CHANGE ORDER #2

Project: #1232.001 - RUSHMORE PLAZA
 CIVIC CENTER MULTIPURPOSE
 ADDITION - BID PACKAGE 2
 Rapid City, South Dakota

Change Order No.: 2

X-1
Sheet No:

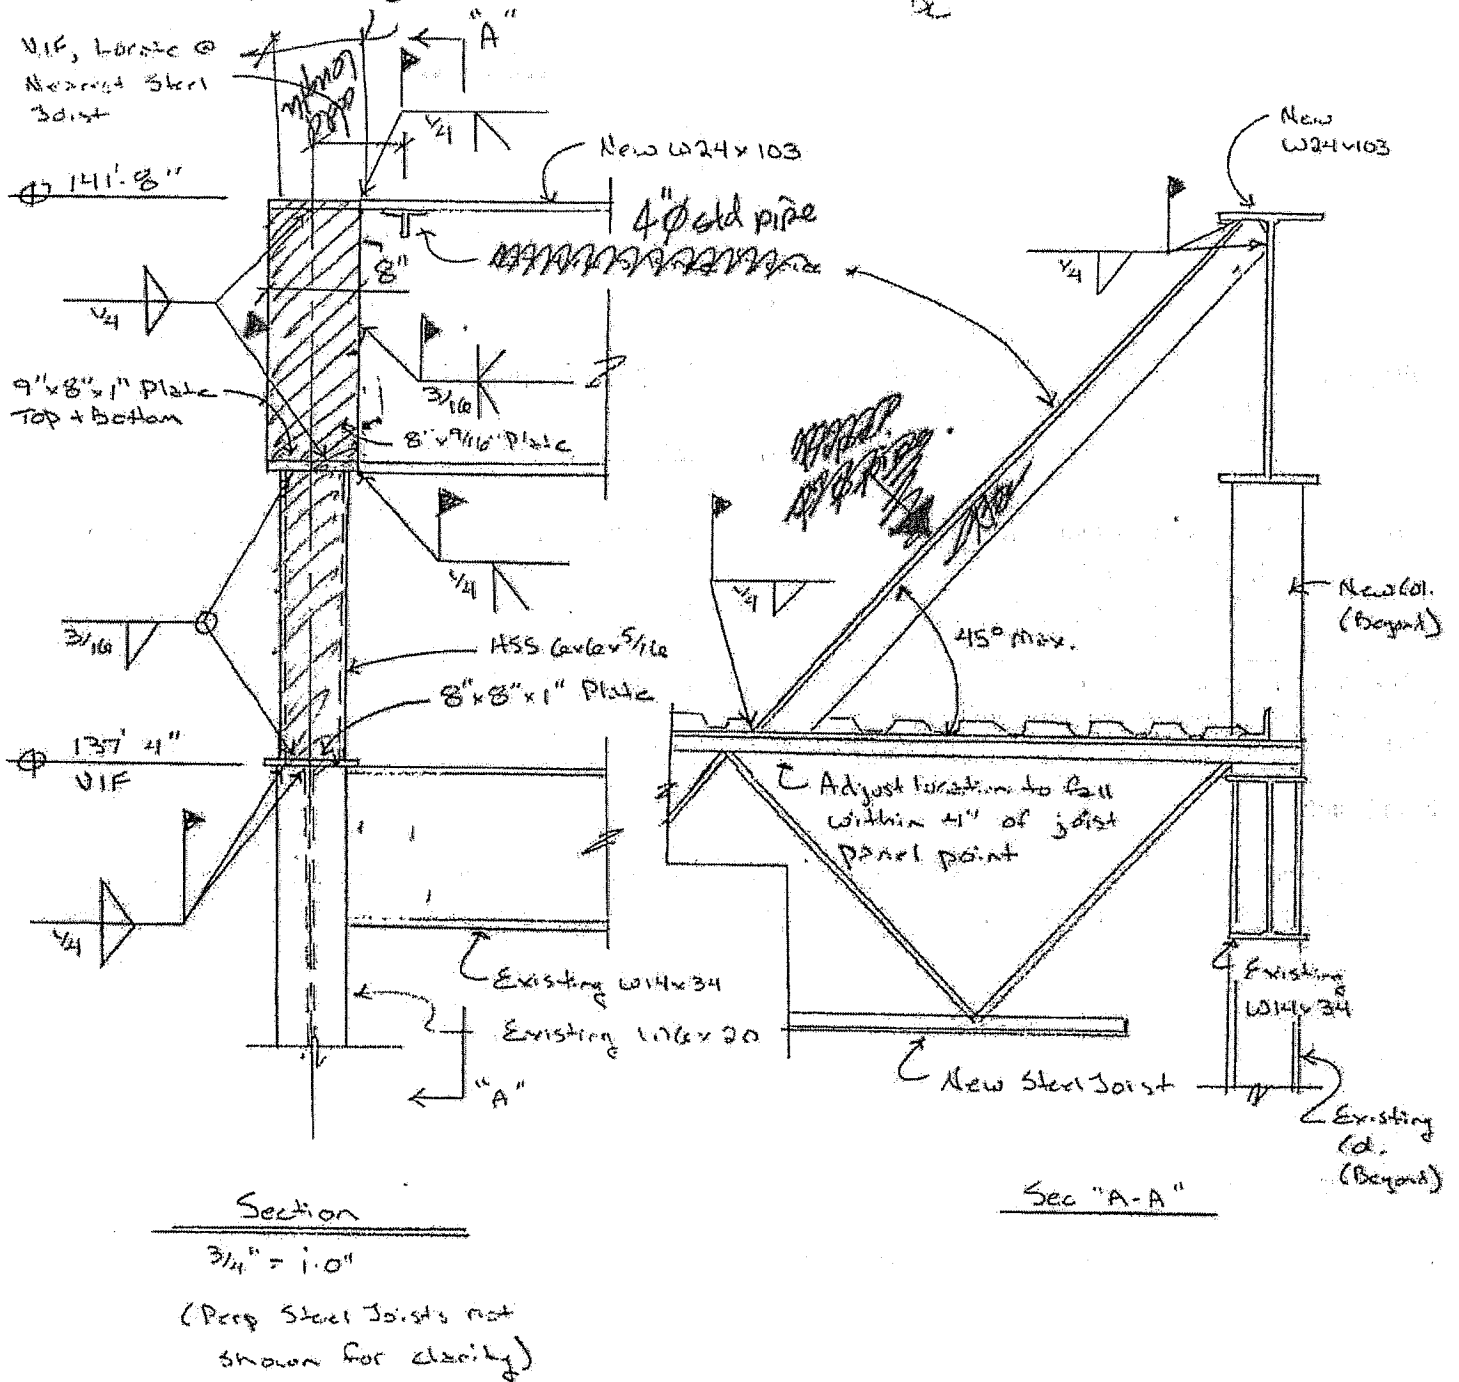
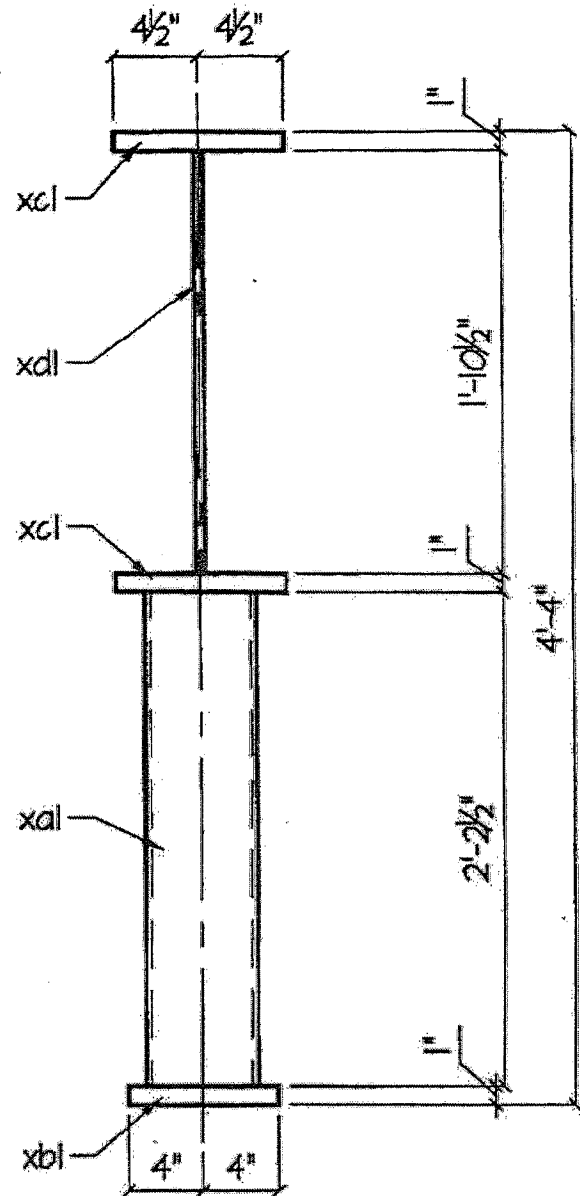
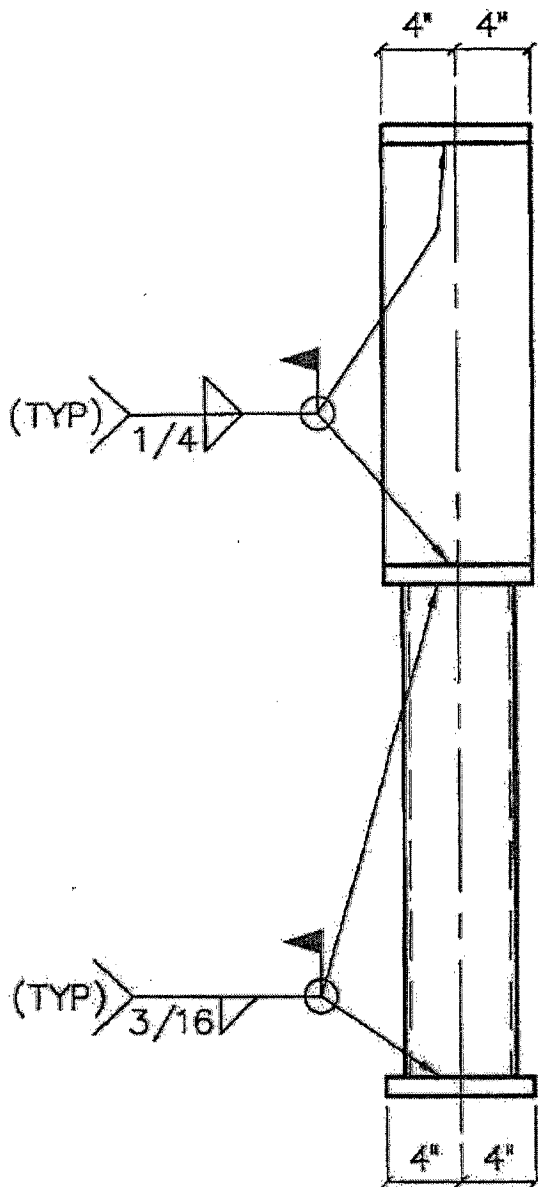
1. Provide costs, breaking out labor and materials, to provide the attached structural revisions. Include necessary roofing revisions.

- 1 – 8-1/2" x 11" – Albertson Engineering sketch.
- 1 – 8-1/2" x 11" – Fargo Tank & Steel Sheet X-1

Sec "A-B"

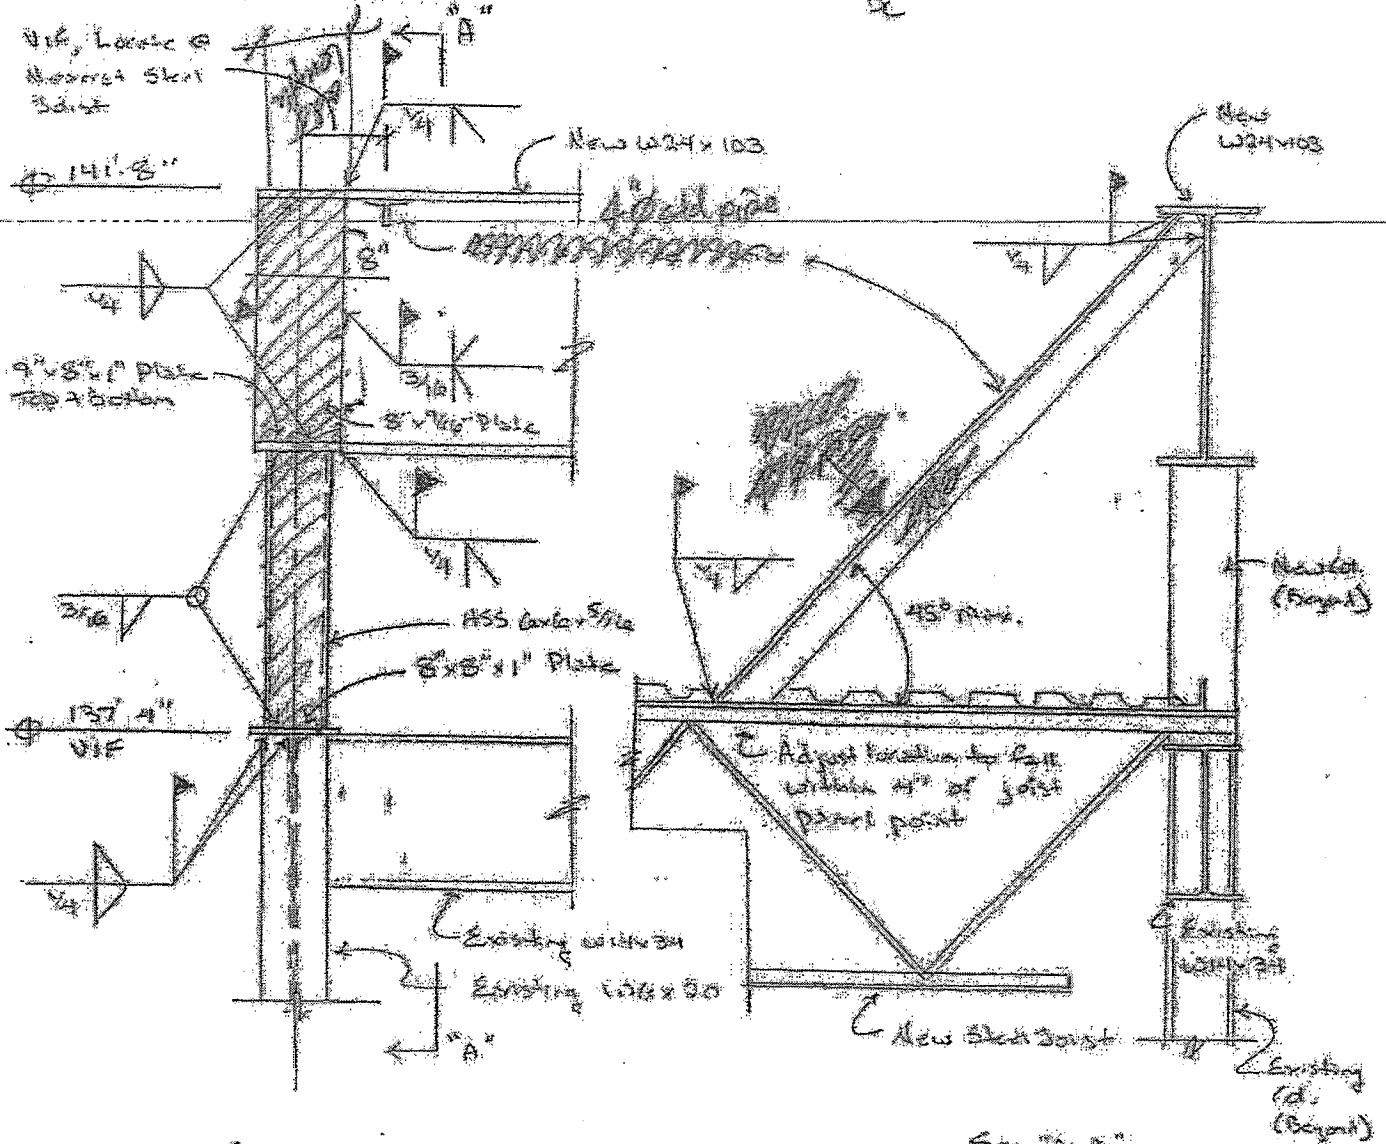
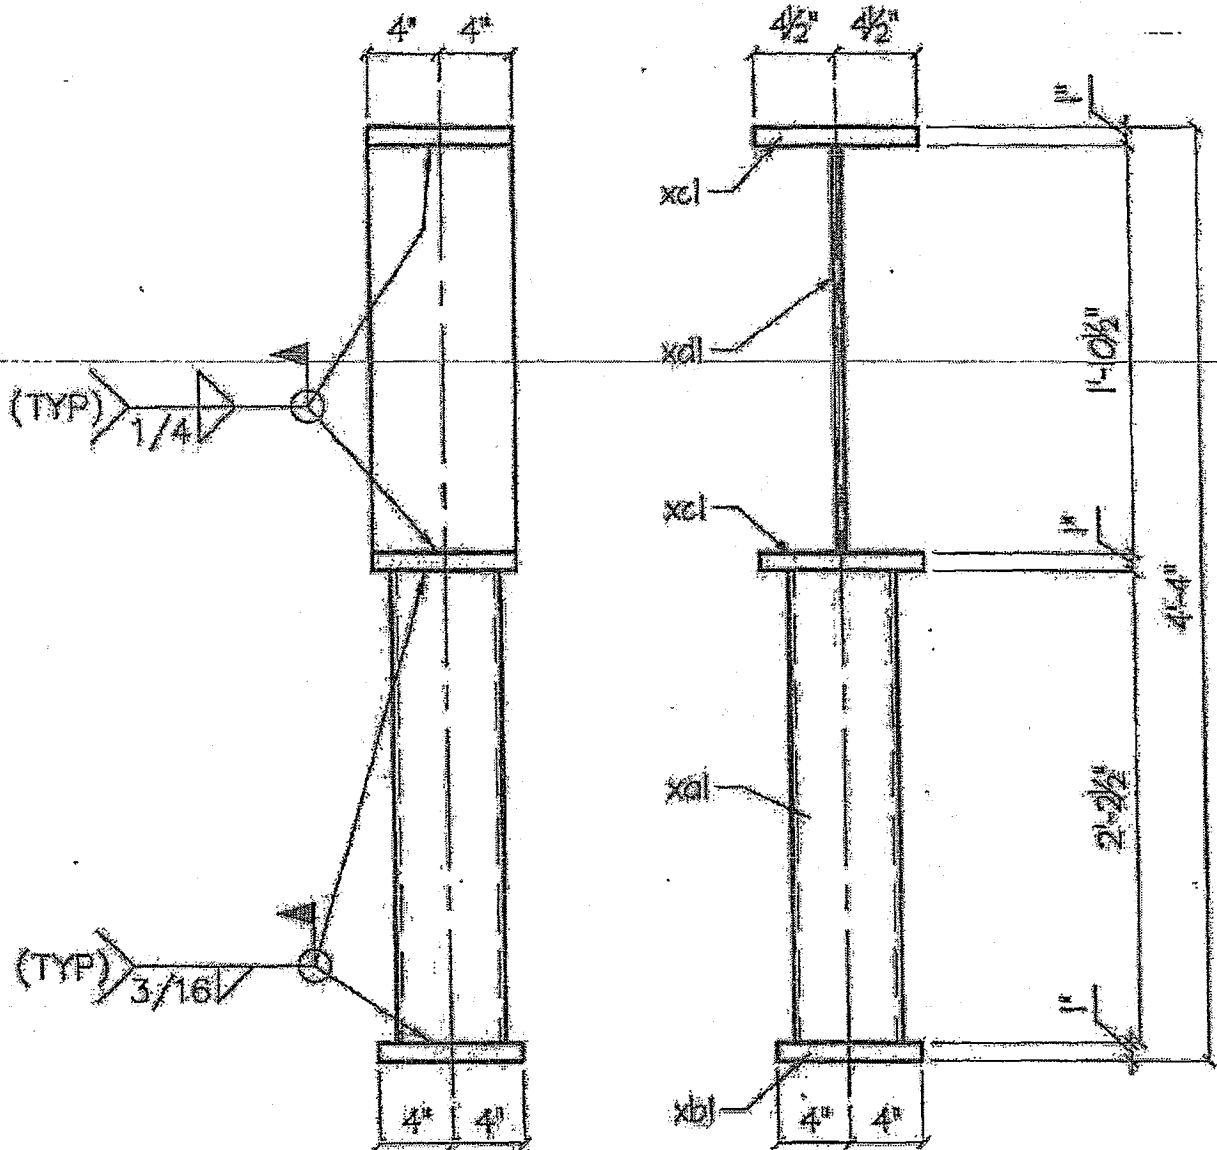
1. Provide costs, breaking out labor and materials, to provide the attached structural revisions. Include necessary roofing revisions.

- 1 – 8-1/2" x 11" – Albertson Engineering sketch.
- 1 – 8-1/2" x 11" – Fargo Tank & Steel Sheet X-1
